## **Arcare Huntlee Racf**

## **Accessibility Report**

**Project Number:** 176732

### Figure 2 Ground Floor Plan

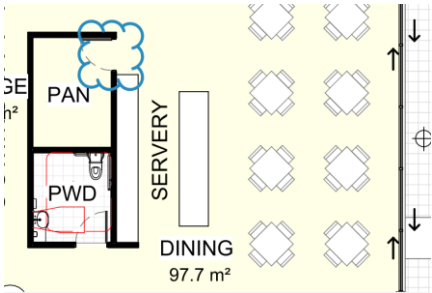
Arcare Huntlee Racf	
BCA Requirement	Comment
<p><b>D4D2 General building access requirements</b></p> <p>Buildings and parts of buildings must be accessible as required by this clause, unless exempted by D4D5.</p> <p>Class 7a To and within any level containing accessible carparking spaces.</p> <p>Class 9c <u>Common areas:</u></p> <p>From a pedestrian entrance required to be accessible to at least 1 floor containing sole-occupancy units and to the entrance doorway of each sole-occupancy unit located on that level.</p> <p>To and within not less than 1 of each type of room or space for use in common by the residents, including a cooking facility, sauna, gymnasium, swimming pool, common laundry, games room, TV room, individual shop, dining room, public viewing area, ticket purchasing service, lunchroom, lounge room, or the like.</p> <p>Where a ramp complying with AS 1428.1 or a passenger lift is installed—</p> <p>(a) to the entrance doorway of each sole-occupancy unit; and</p> <p>(b) to and within rooms or spaces for use in common by the residents, located on the levels served by the lift or ramp.</p>	<ul style="list-style-type: none"> <li>▪ The level of access required by the BCA will be assess in the below tables.</li> </ul>

Arcare Huntlee Racf	
BCA Requirement	Comment
<b>Table D4D2</b> <ol style="list-style-type: none"> <li>Based on 96 SOU's not less than 5 shall be accessible and designed in accordance with AS 1428.1.</li> <li>Where more than 2 accessible sole-occupancy units are required, they must be representative of the range of rooms available.</li> </ol>	<ul style="list-style-type: none"> <li>Five rooms have been nominated as Accessible, these include Room 33, 39, 50, 56 and 88. Internal clearances are to be assessed during the CC Stage once documentation has developed to capture joinery.</li> <li>Compliance is achievable and will be assessed during the CC Stage once documentation has developed to capture joinery.</li> </ul>

Arcare Huntlee Racf	
BCA Requirement	Comment
<p><b>D4D3 Access to buildings</b></p> <p>3. An accessway must be provided to a building required to be accessible—</p> <ul style="list-style-type: none"> <li>○ From the main points of a pedestrian entry at the allotment boundary; and</li> <li>○ from another accessible building connected by a pedestrian link; and</li> <li>○ from any required accessible carparking space on the allotment.</li> </ul>	<ul style="list-style-type: none"> <li>■ Based on current floor plan, the following comments are in relation to the path of travel from the allotment boundary to the Principal Pedestrian Entrance of the building. To ensure compliance is achieved, the following is to be adopted into the drawings in accordance with Clause 10.2 of AS 1428.1:</li> <li>■ Walkways to comply with Clause 10.2 of AS 1428.1 including: <ul style="list-style-type: none"> <li>○ Sides of the walkway are to be firm and level surface of a different material to that of the walkway at the same level of the walkway, follow the grade of the walkway and extend horizontally for a minimum of 600 mm, unless provided with a Kerb, Kerb rail and handrail or wall min 450mm high.</li> </ul> </li> <li>■ Compliance to be verified at CC stage once documentation has developed.</li> <li>■ Two (2) lifts are provided between the accessible carpark within the basement and the building.</li> </ul>
